CROSSROADS NORTH PRELIMINARY PLAN

PCD FILE NO: SP207

CROSSROADS NORTH
PRELIMINARY PLAN
PRELIM PLAN 2

Preliminary Plan Drawings_v2.pdf Markup Summary 6-23-2022

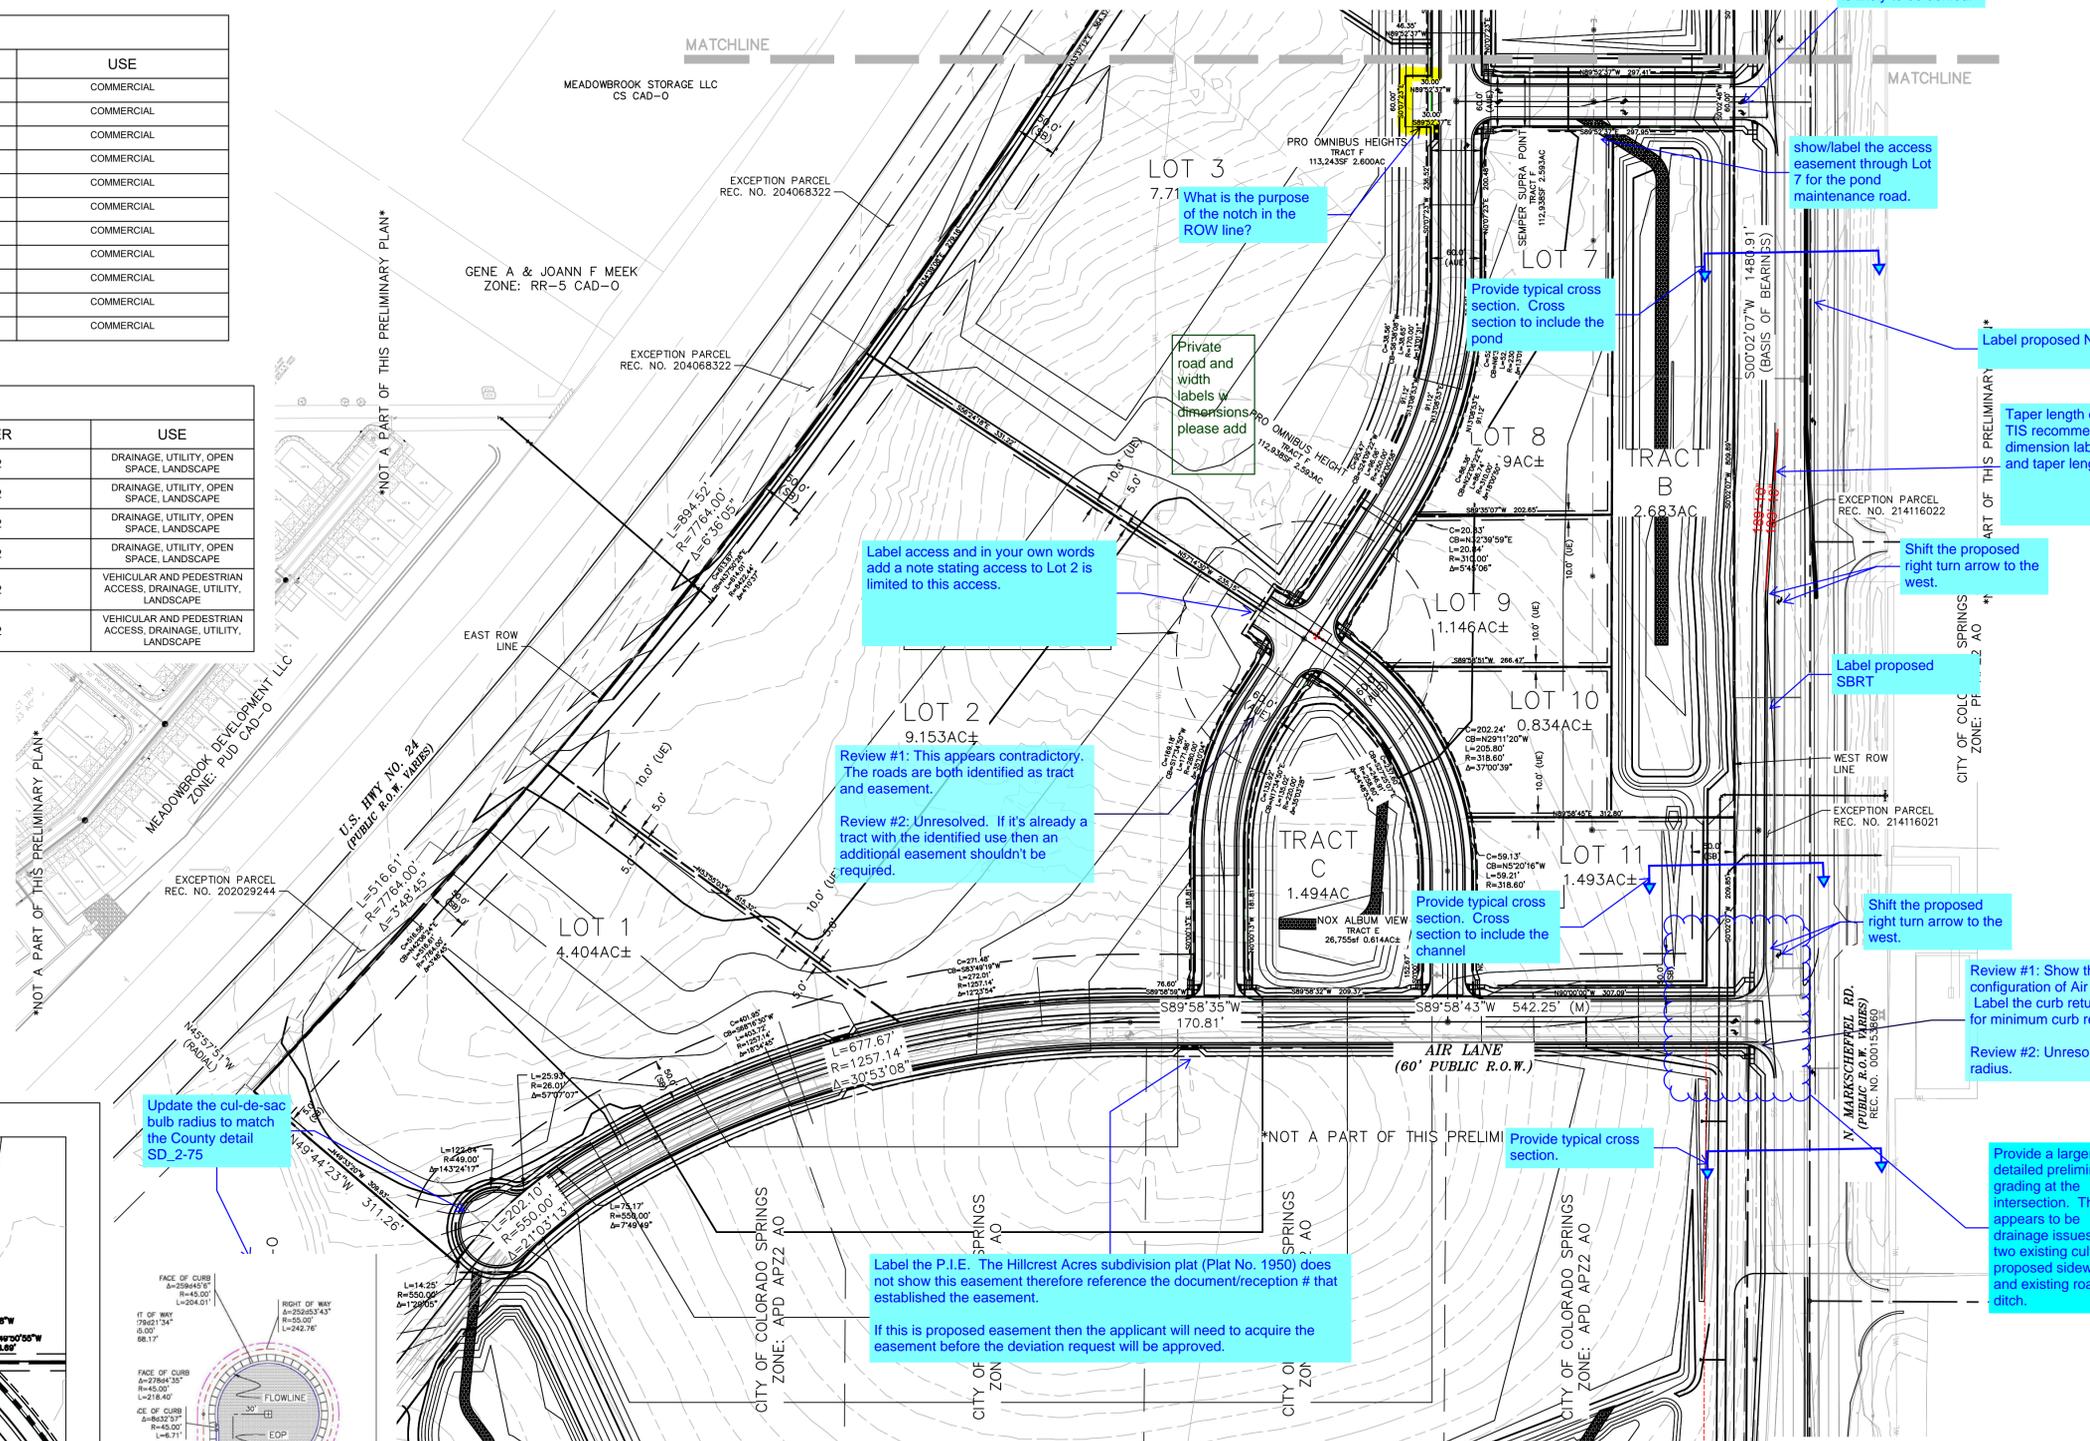
Revise to Right-In/Right-Out. See comment on the deviation request. The deviation request is likely to be denied.

What is the purpose of the notch in the ROW line?

show/label the access easement through Lot 7 for the pond maintenance road.

Provide typical cross section. Cross section to include the pond

Label proposed NBLT

Taper length does not meet criteria or the TIS recommendation. Revise and provide dimension label for all turn lane striping and taper length for all proposed locations.

Label access and in your own words add a note stating access to Lot 2 is limited to this access.

Shift the proposed right turn arrow to the west.

Label proposed SBRT

Review #1: This appears contradictory. The roads are both identified as tract and easement.

Review #2: Unresolved. If it's already a tract with the identified use then an additional easement shouldn't be required.

Shift the proposed right turn arrow to the west.

Provide typical cross section. Cross section to include the channel

Review #1: Show the proposed roadway configuration of Air Lane and the intersection. Label the curb return radius. See Table 2-31 for minimum curb return radius.

Review #2: Unresolved. Label the curb return radius.

Provide a larger detailed preliminary grading at the intersection. There appears to be drainage issues with two existing culverts, proposed sidewalk and existing roadside ditch.
